35–039 Detroit New Final Drive Standard Performance Forward Carrier Change to Top Performance Passive Lube Management

TSB-35-039-FTL

Description of Revisions: The bulletin replaces the version dated 01/26/ 2023. The oil specification has been updated.

Fig. 1, Original Standard Performance Carrier without a Lube Management System

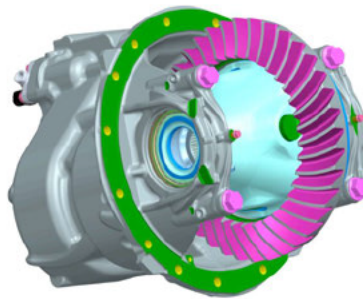
Detroit New Final Drive Standard Performance Axles will have a change to the lube management system. Initially launched without a lubrication management system, the forward rear axle will change to a passive management system. This will be the same passive lube management system as the New Final Drive Top Performance Axle with passive lube management.

The parts will supersede in Excelerator. This change is happening to the forward-rear carrier only. See Fig. [1](#), Fig. [2](#), and Fig. [3](#).

Fig. 4, New Fill Locations for New Final Drive with Passive Lube Management System

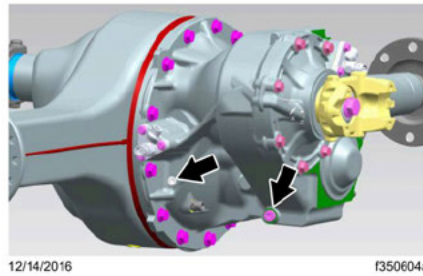
Oil fill locations will change to match the New Final Drive Top Performance locations. See Fig. 4. The type of approved oil is DFS93K219.01 only. The rear fill plug on the axle housing will change to MBA 6809900117, and it will be installed from the inside, similar to the Top Performance carrier. See Fig. 5.

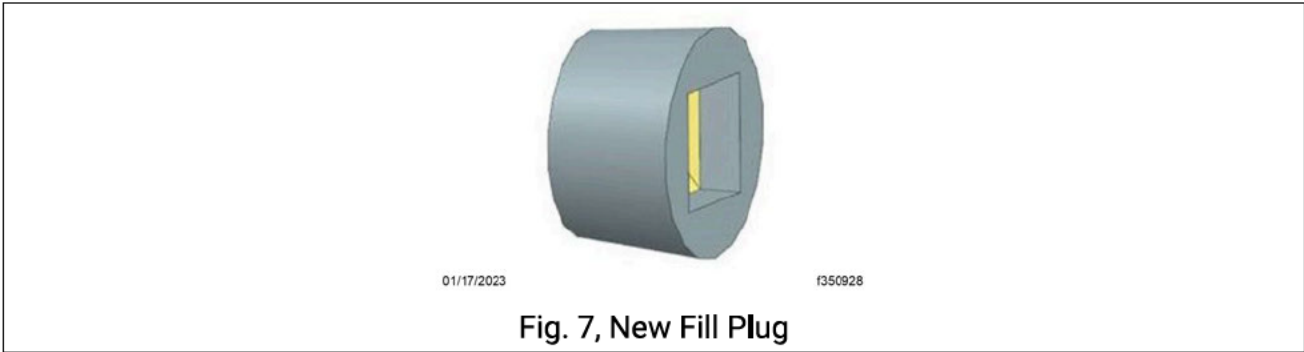
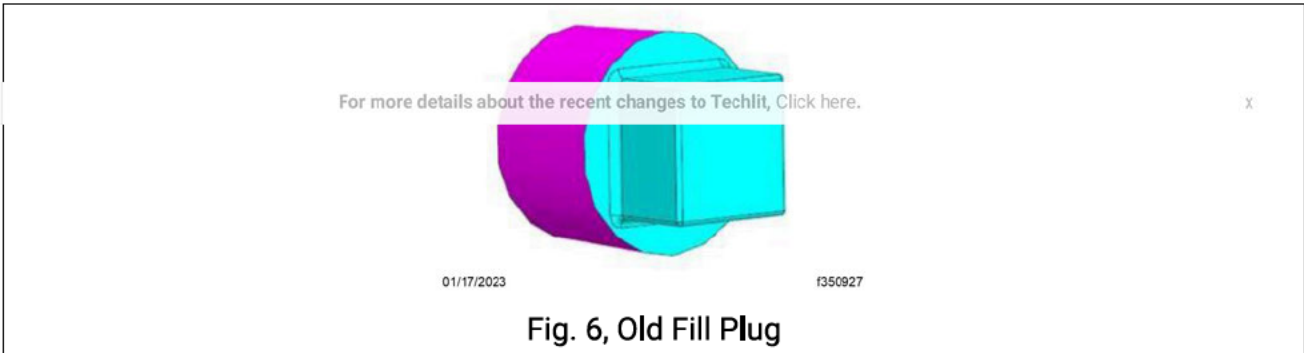
1. In order to replace the carrier, clean the housing, and remove the external fill plug from the axle housing.
2. Install the new fill plug (MBA 6809900117) from the inside of the housing. See Fig. 6 and Fig. 7.
